Historic District Commission

City of Kalamazoo

Tuesday, February 20, 2024

E. APPLICATION REVIEWS

DEMO ELEVATIONS
& WALL SECTIONS

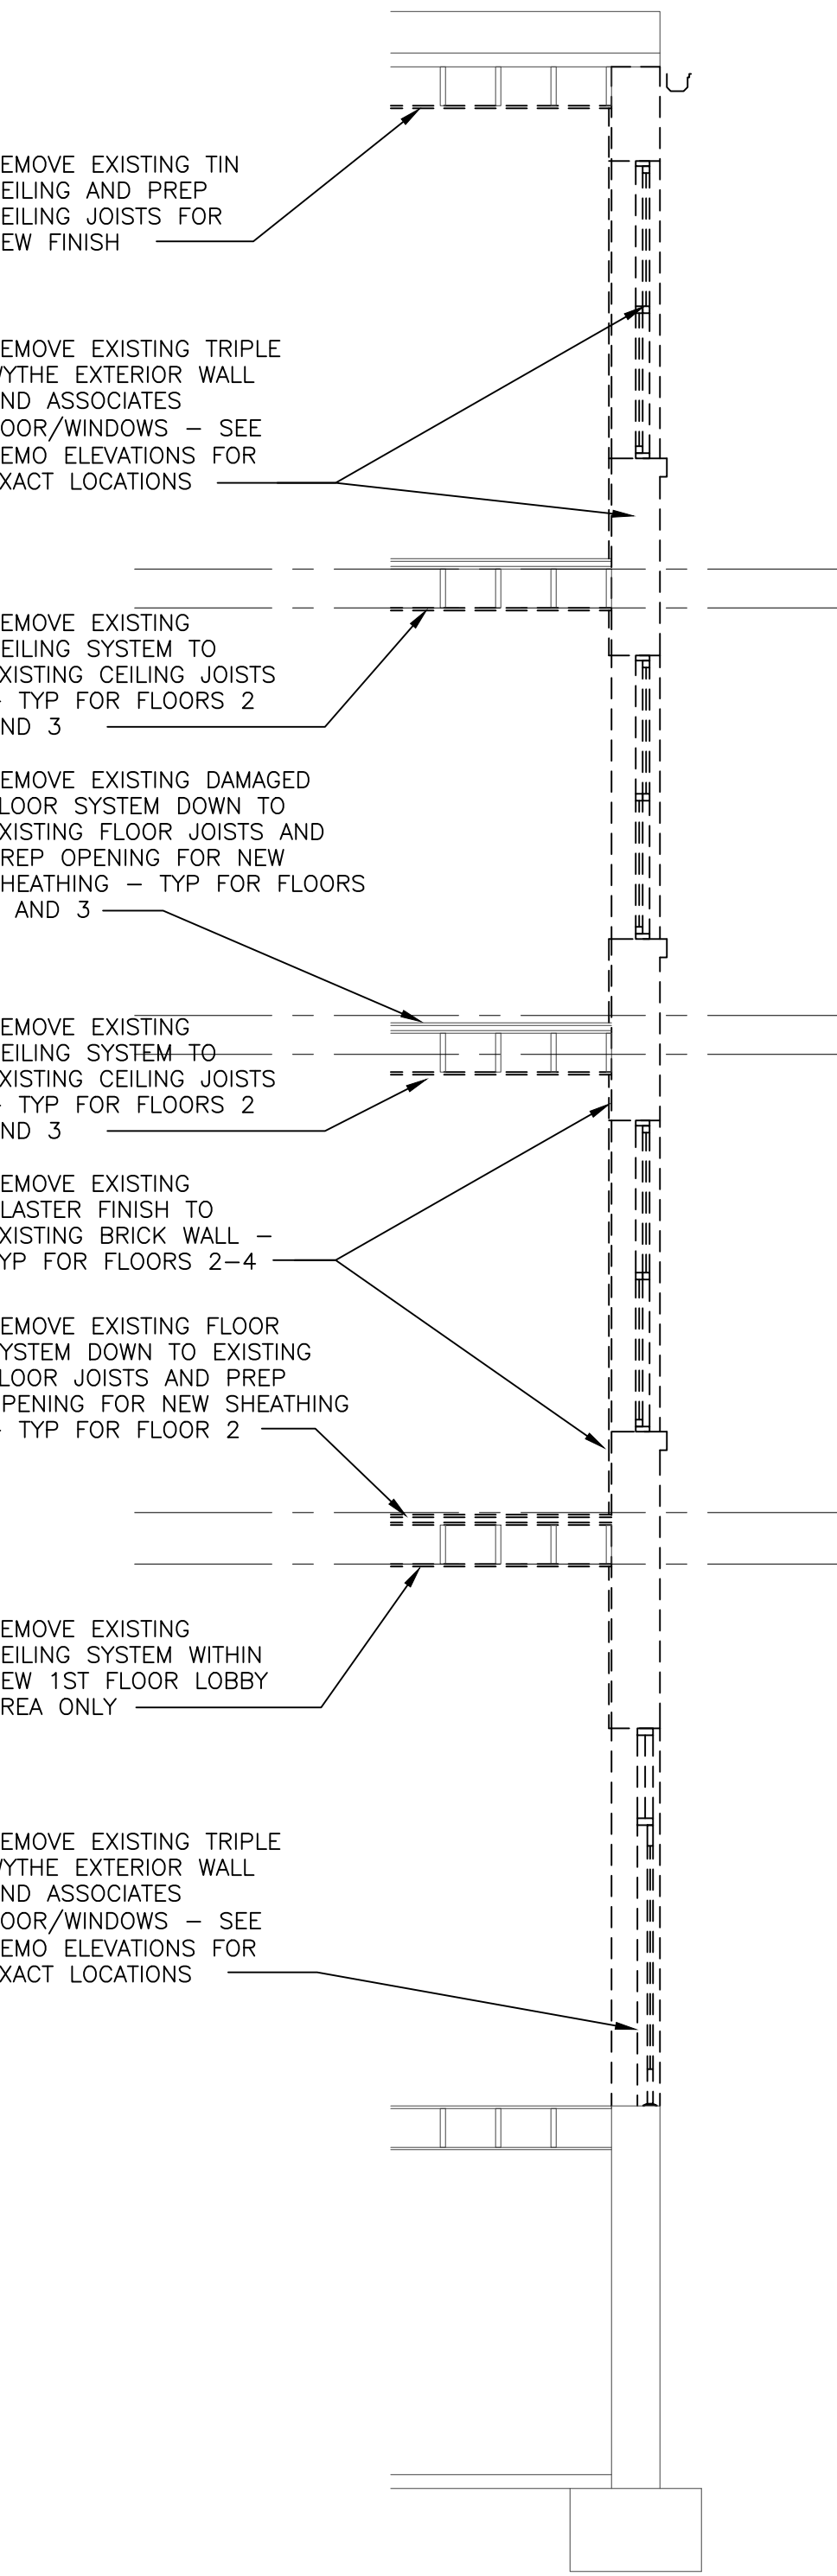
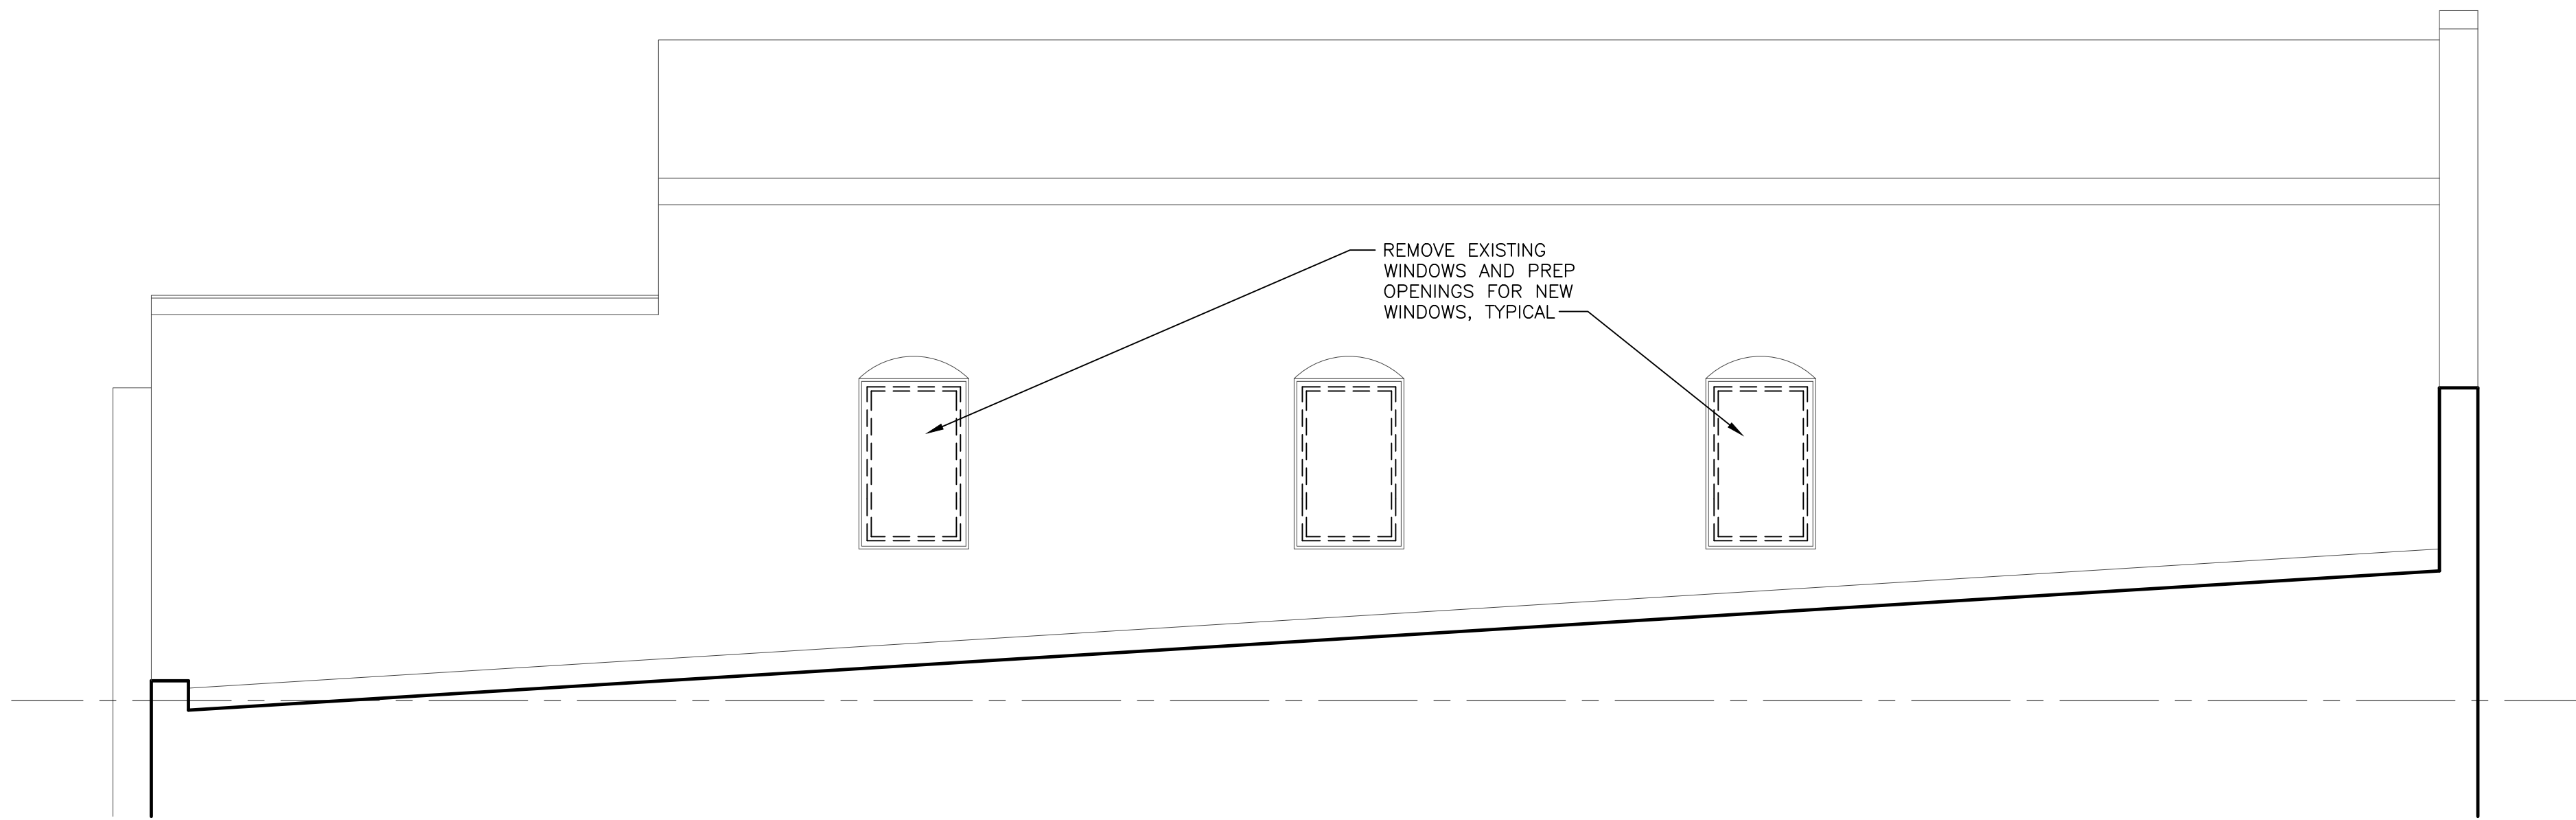
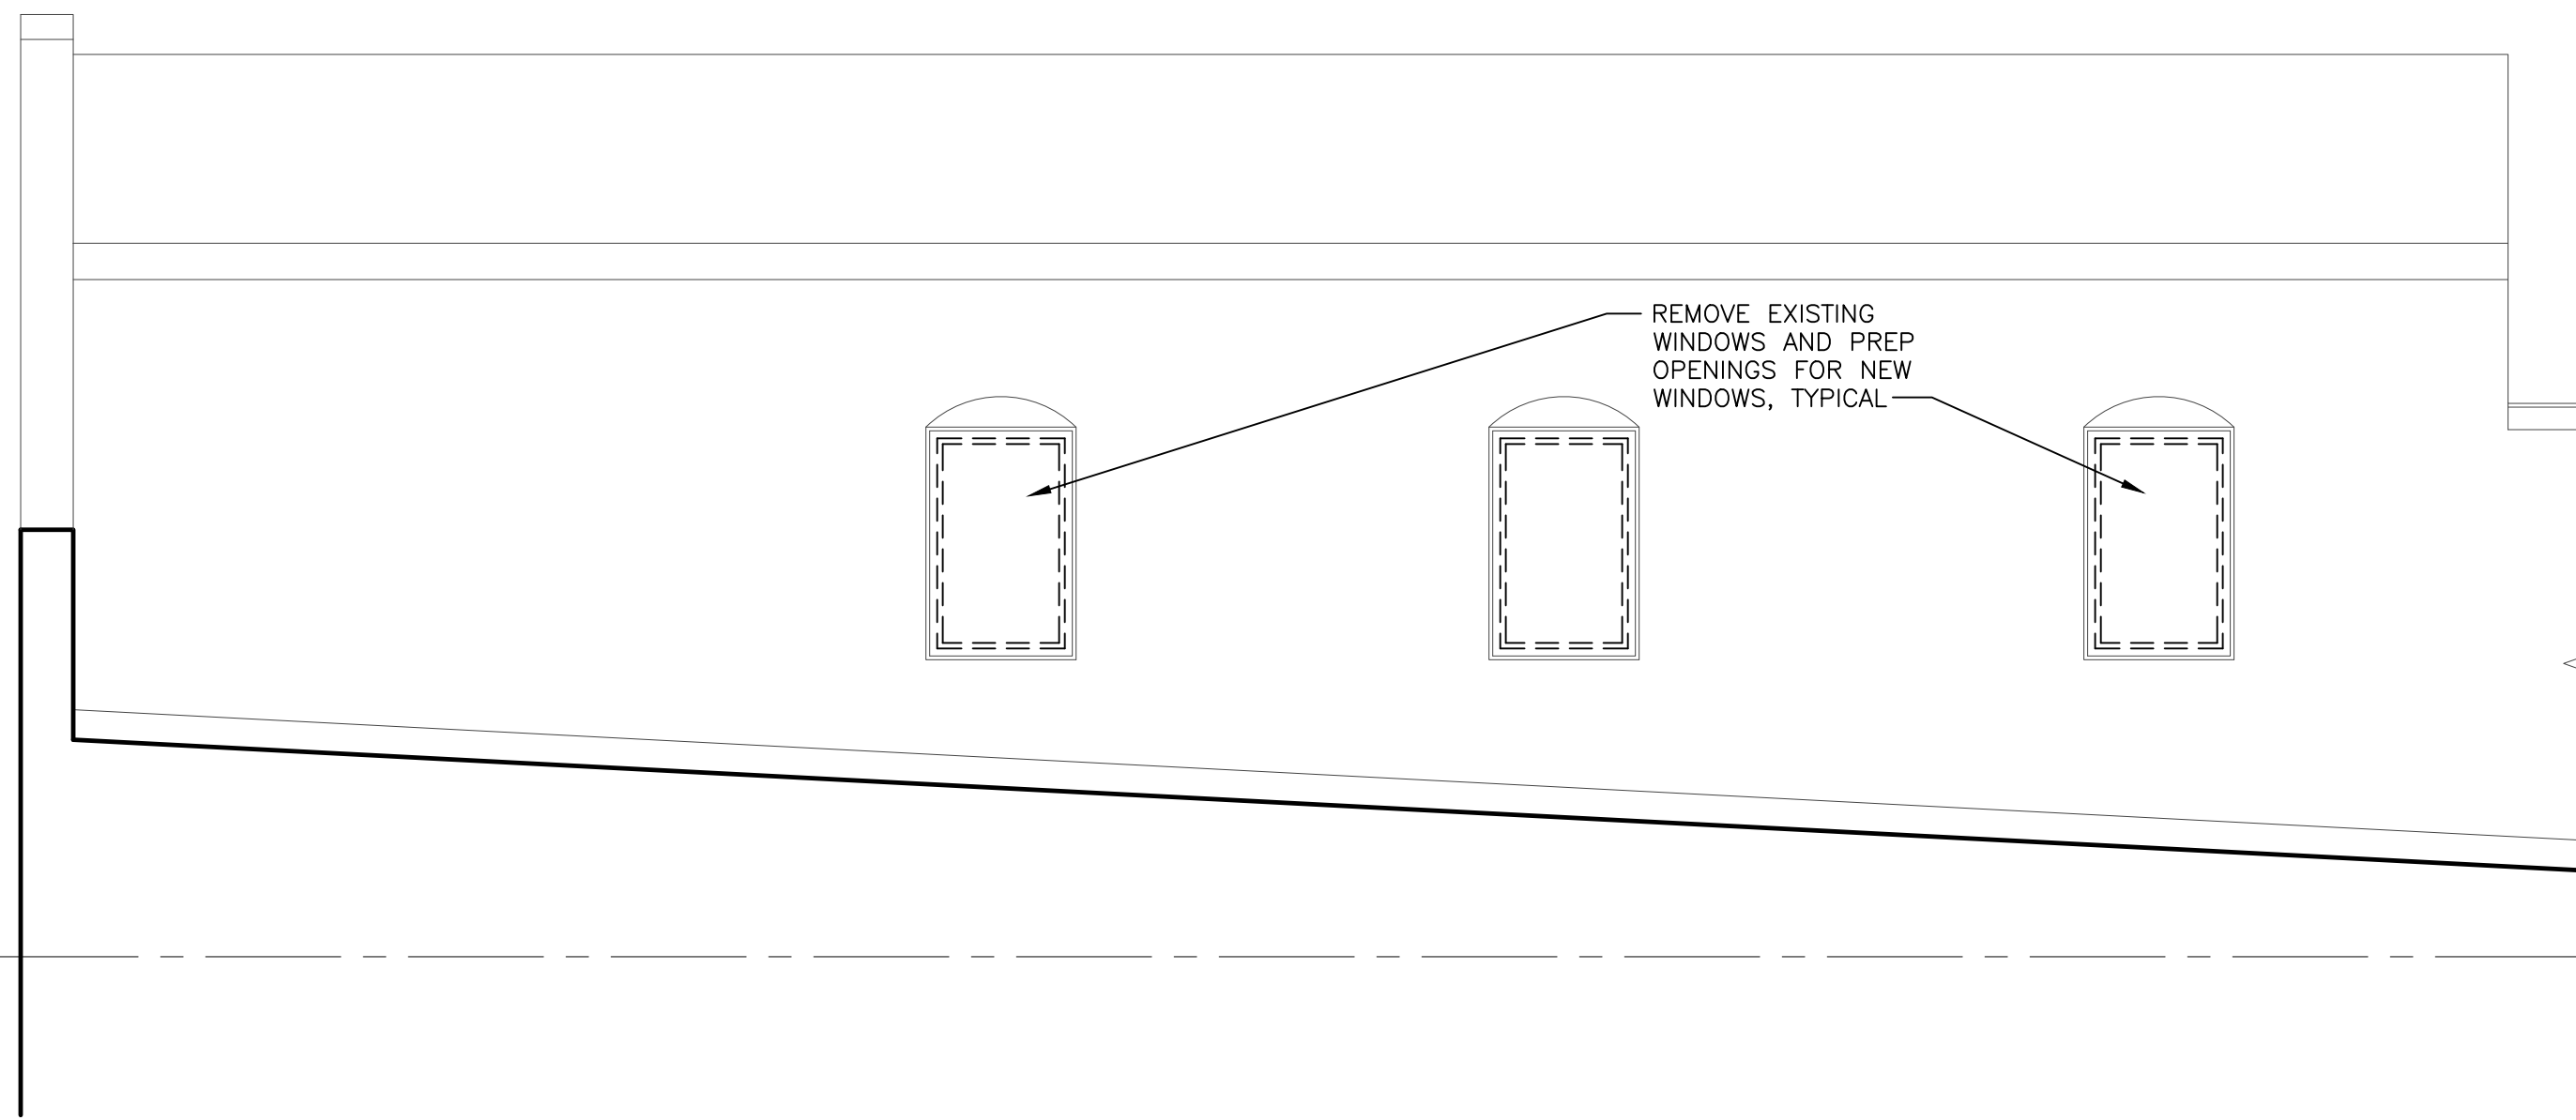
It should be noted that the approved iteration of the tower from 2021 was revised once to more closely align the fenestration and masonry with the existing building. This iteration of the building, however, will be taller than the historic structure. (See page A2.00 in the drawings provided). Even though the tower being taller than the historic building, the tower will still be compatible with the structure. It is unlikely that the tower will be visible from the street when looking at the front of the building.

The window replacements will remove numerous character defining features of the property. Additionally, it is unclear why the windows are slated for removal.

1. The proposed work complies with the Secretary of the Interior standards 1, 2, 9 and 10. **Action: Motion to approve a Certificate of Appropriateness for the work as described in the application.**
2. More information is needed. **Action: Motion to postpone until the HDC meeting on 19 March 2024 and direct the applicant to provide the requested materials and information to the Historic Preservation Coordinator by noon on 12 March 2024.**
3. Denial of the application. **Action: Motion to deny the application based on Secretary of the Interior Standards 1, 2, 9 and 10.**
